MEMORANDUM

To: Planning Commission
From: Kinsey O'Shea, AICP, Senior Town Planner
Date: February 10, 2023
Subject: RZN22-0004 Glade Spring Crossing

TO: Kinsey O’Shea, Town Planner/Current Development
 FROM: Kafi Howard, Town Engineer
 DATE: February 9, 2023
 SUBJECT: RZN 22-0004-Glade Spring Crossing - 1006 Glade Road – Stormwater Concept Plan
 Memo (updated to February 7th revision)

SUBJECT: Glade Spring Crossing Sewer Connection

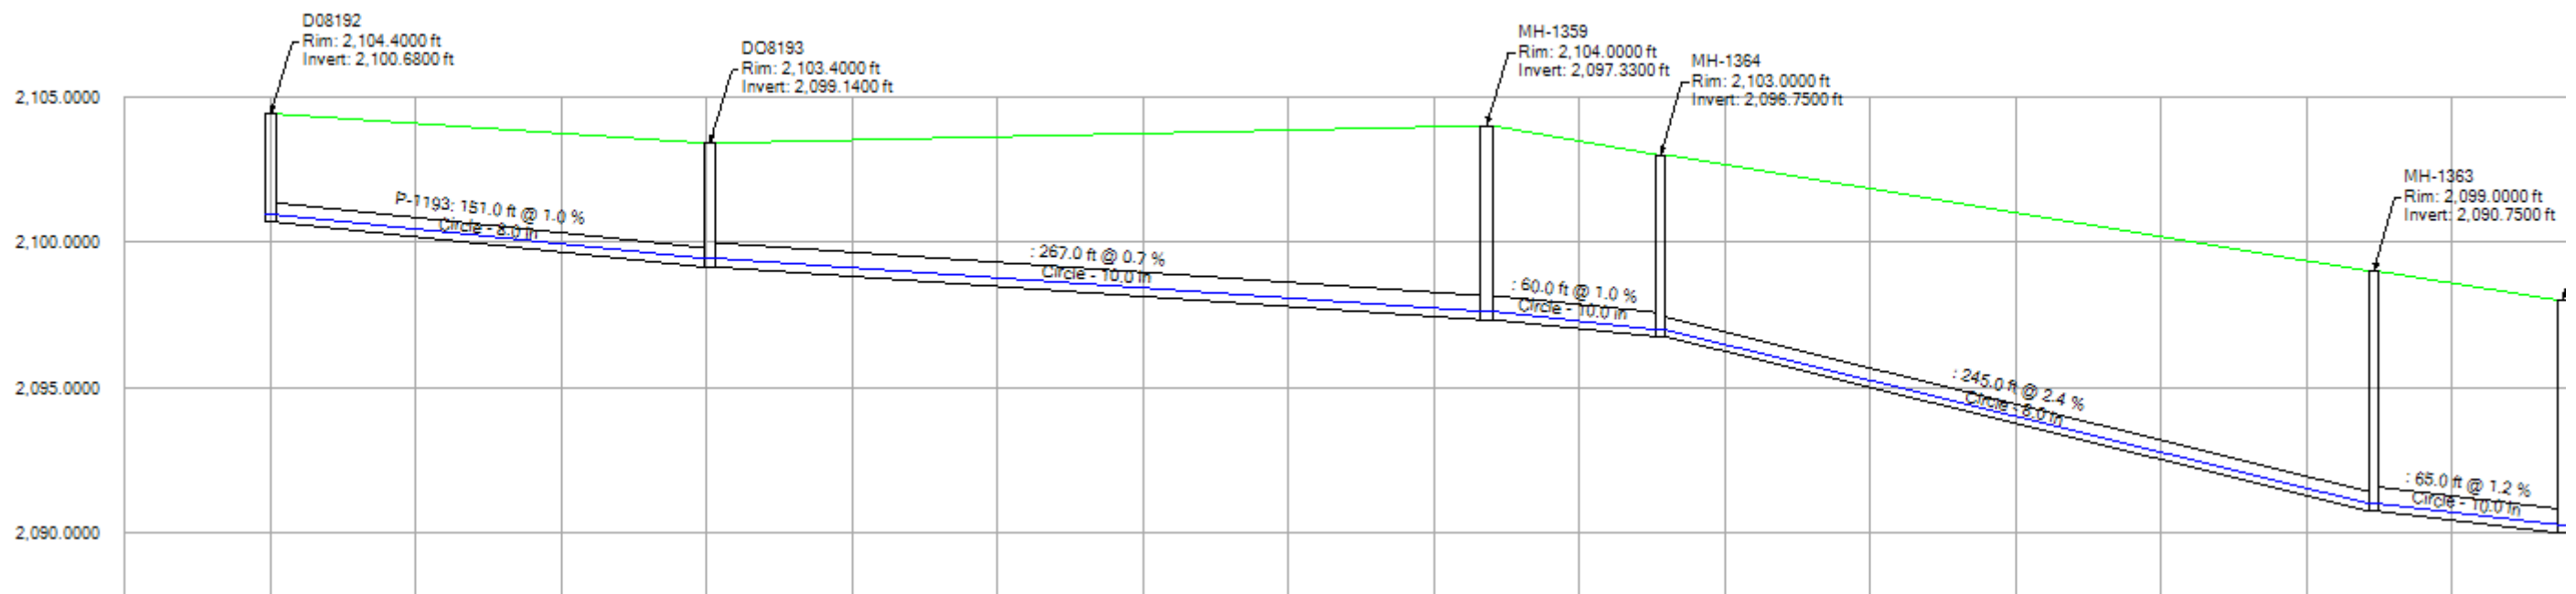
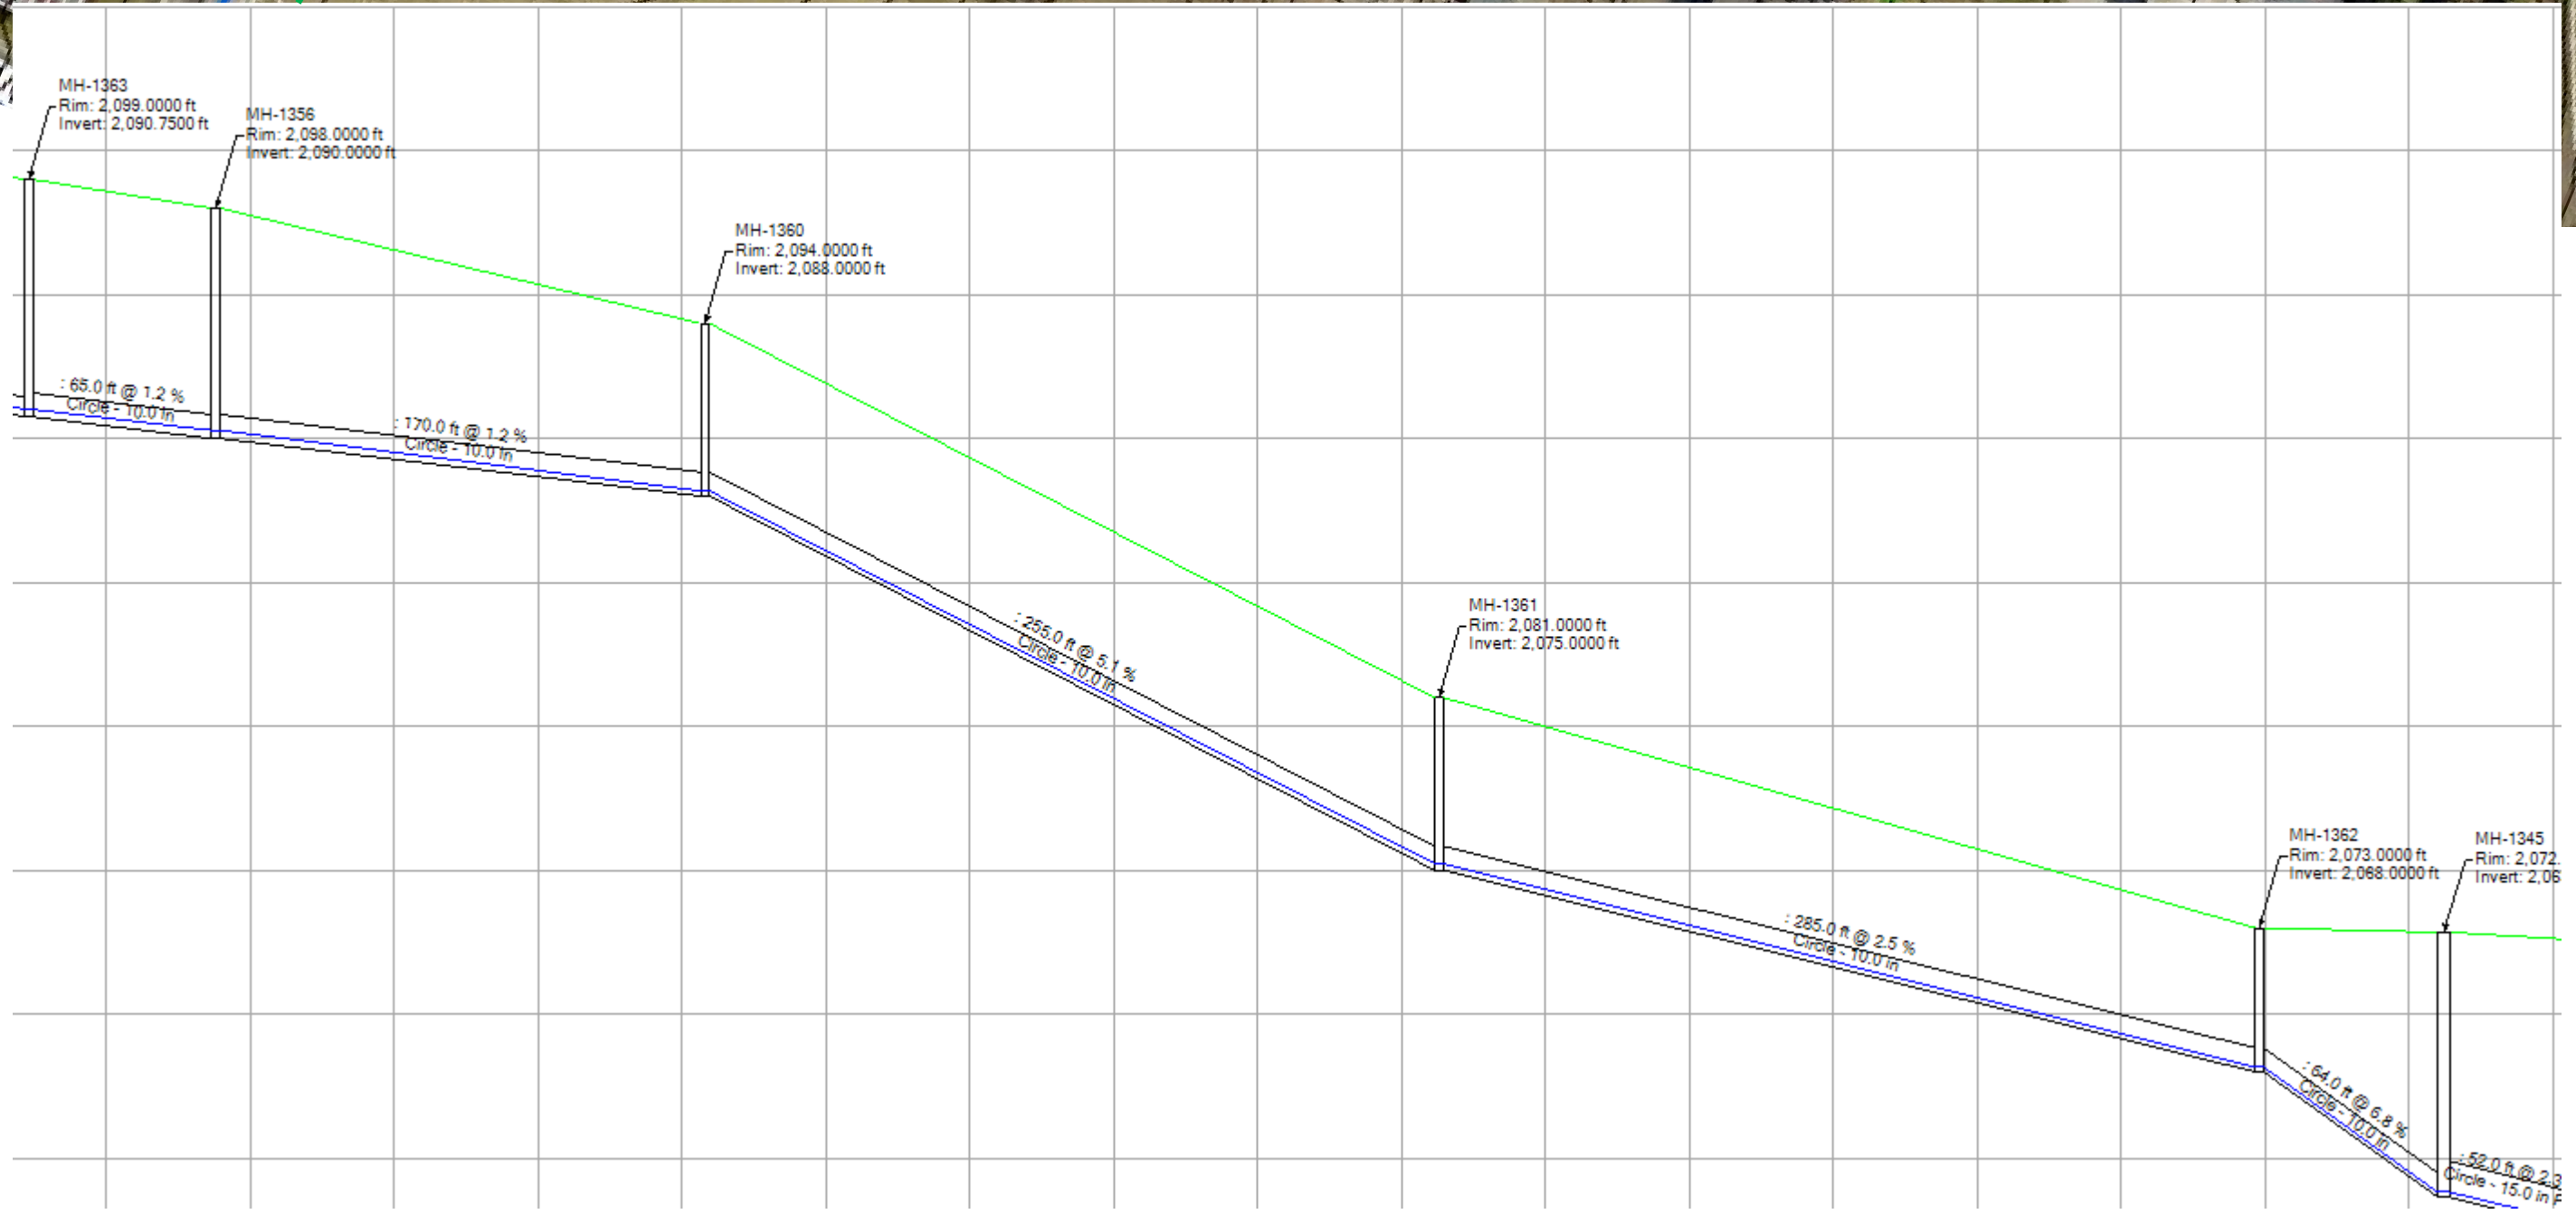
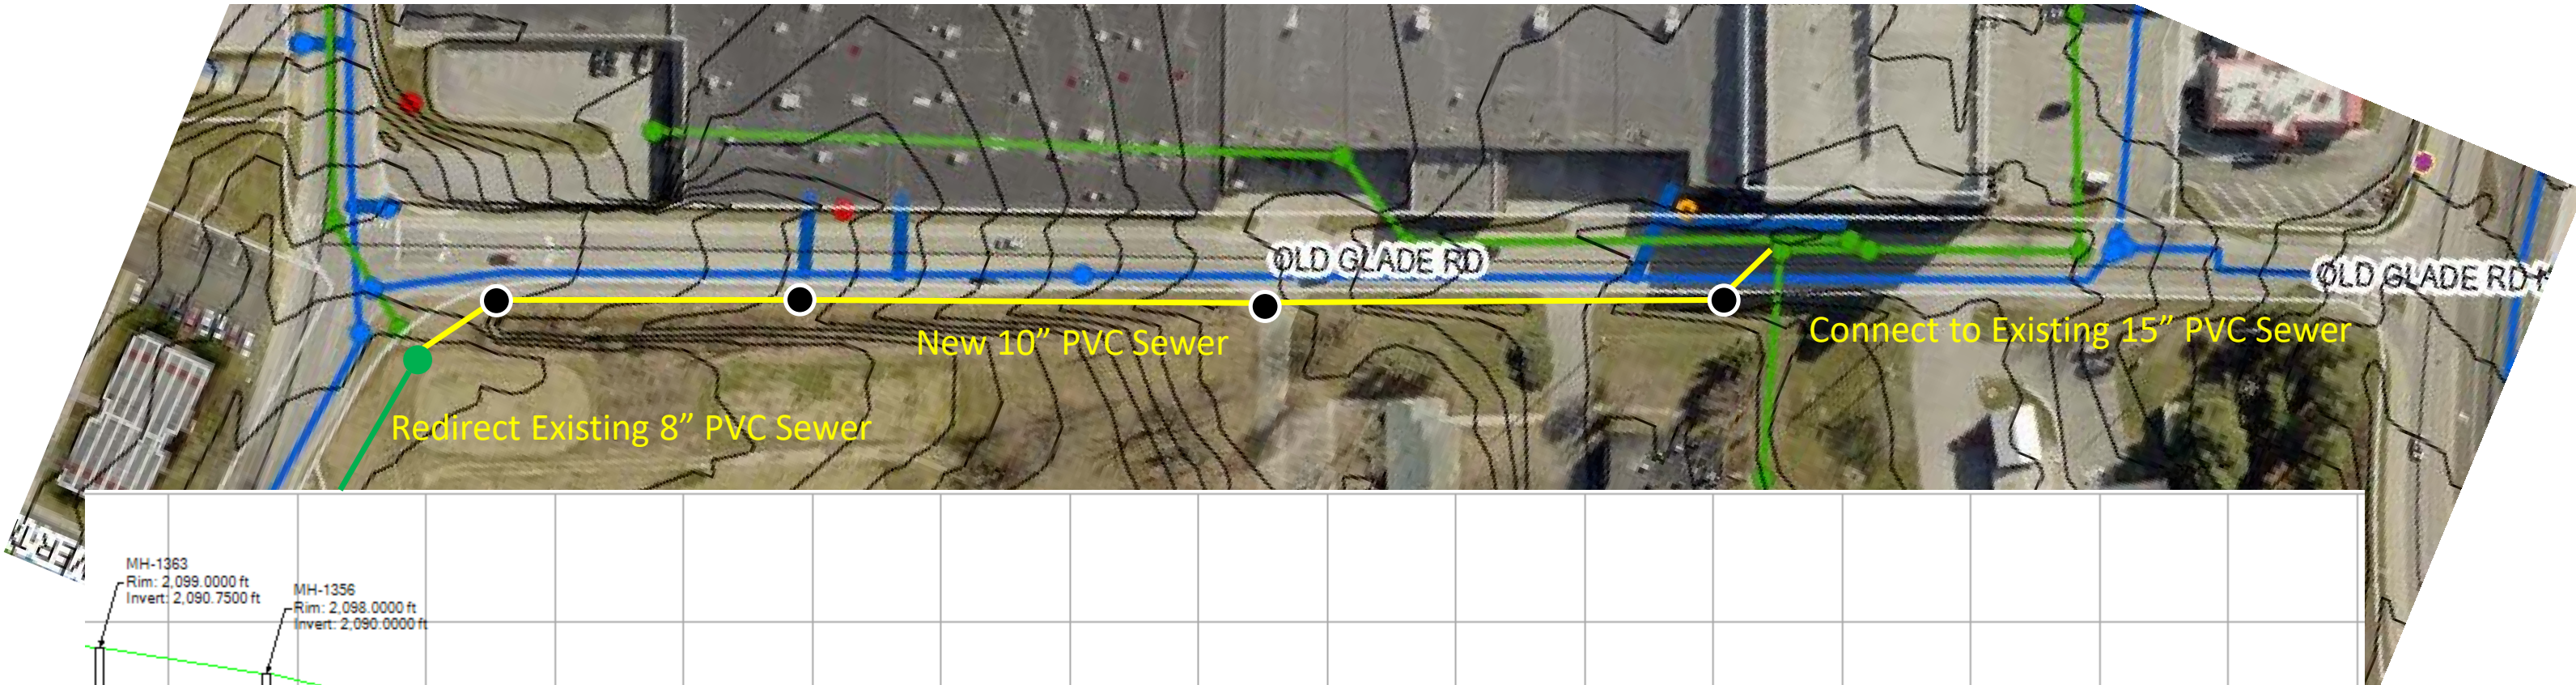
- 2) Replacing the 450 LF of common force main along Glade Road with a new larger 8" diameter force main as shown on the attached figure. Approximately 200 feet of this force main is suspended beneath the bridge over US 460 and replacement of this section of pipe will require VDOT approval. The estimated cost of this replacement is \$140,000 and it includes a new manhole with an air/vacuum release valve near Olive Drive.

- 3) Redirecting the discharge from the proposed new force main to new 10" gravity sewers that would run along Glade Road to the intersection with Old Glade Road and then down Old Glade Road to a 15" sewer behind the University City mill parking garage. Two existing sections of 8" pipe along Glade Road would be reused. Preliminary plans and profiles for this work are attached. The estimated cost of the work is \$800,000.
